Addendum No. 1
Flume 18 Reconstruction
Contract No. 0910-100
September 23, 2009

**FLUME 18 RECONSTRUCTION
ADDENDUM #1**

**FIGURE
A1**

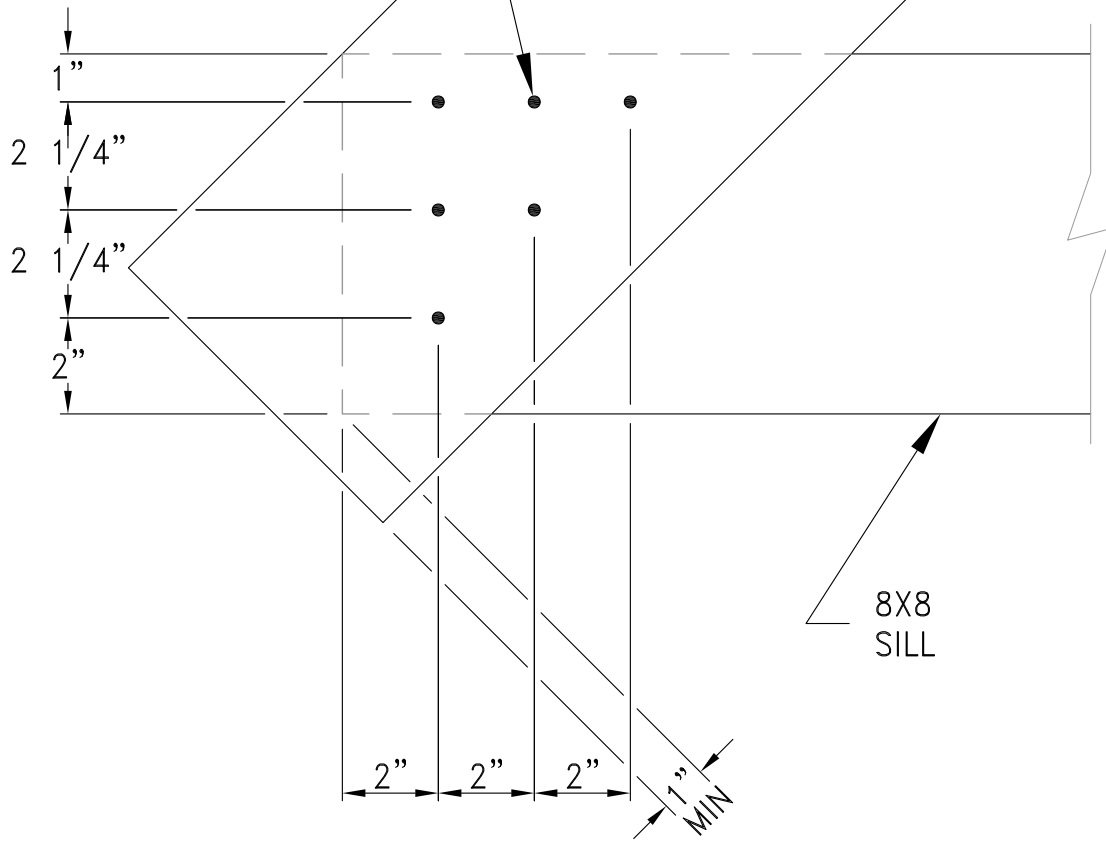
3. **Drawing Change.** ADD Detail 4/F2 to Drawing F2 as shown on attached Figure A1.
4. **Specification Change.** MODIFY the date for 100 percent completion in Article 2.01, subparagraph B to read (changes in bold):
“The Work shall be 100 percent complete no later than **May 12, 2010.**”

30d (0.192" x 4 1/4") SINKER
NAILS (6 TOTAL) SPACED
AS SHOWN.

1. PREDRILL HOLES IF REQ'D TO PREVENT SPLITTING.
2. CONNECTION AT SILL IS SHOWN; CONNECTION AT POST IS SIMILAR.
